## Addendum No. 4

Date: 05-20-2024

Project Name: NECSD – New CTE Building

CSArch Project No. 108-2303

**1** ELECTRICAL SITE PLAN  
ES100 1" = 40'-0"

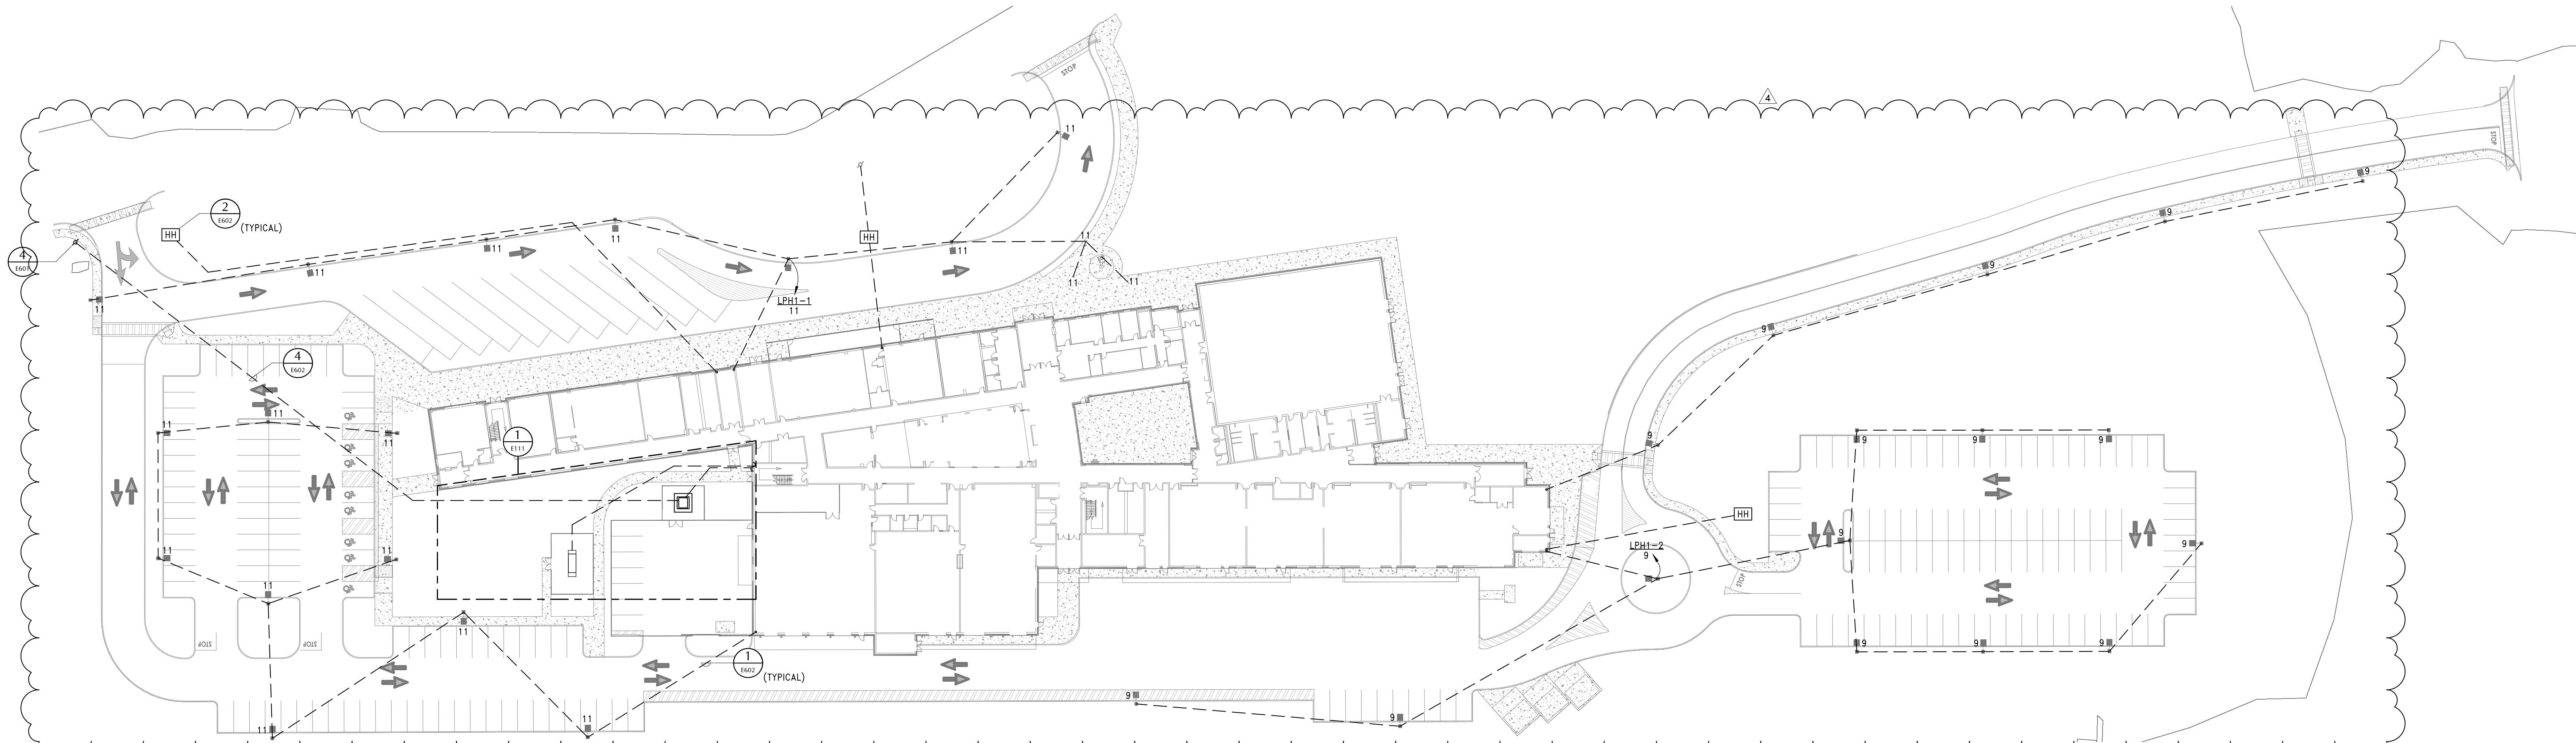
65	E	Site Lighting	In addendum #2, revised drawing C180 was issued which shows 25 type A site light fixtures. Drawing ES100 shows 29 site light fixtures (16 type 9 and 13 type 11) Should the electrical site drawing be updated to only show 25 fixtures? Also ES100 calls for 3 flood lights for the flagpole. Can you provide a part # for these?	5/13/2024	J&J Sass Electric Inc.	Revised as part of addendum #4.	Yes	C180, C230, ES100		Add #4
66	G	AISC Certification	Do you intend on waiving the AISC certification for this project or keeping it? Please let me know when you get the chance.	5/13/2024	Rizzo Companies	AISC certification is required. Bid as per specification section 051200, 1.5, D	No			
67	M	Weld Shop Collectors	<p>For the weld shop collector, please ask them which number they want below (1 or 2 ?):</p> <p>1.One collector composed of 1 module with 3800sqft of filter media</p> <p>2.One collector composed of 2 modules each with 3800sqft of filter media x 2 = 7600sqft total</p> <p>And for the weld shop collector's blower. Please ask them which number they want below (1, 2, or 3 ?):</p> <p>1.One 13000cfm blower and motor</p> <p>2.Two 6500cfm blowers and motors</p> <p>3.Two 7400cfm blowers and motors"</p>	5/13/2024	ADE Group	Refer to welding filtration unit schedule on sheet M902 and welding fume exhaust specification 233505.	No
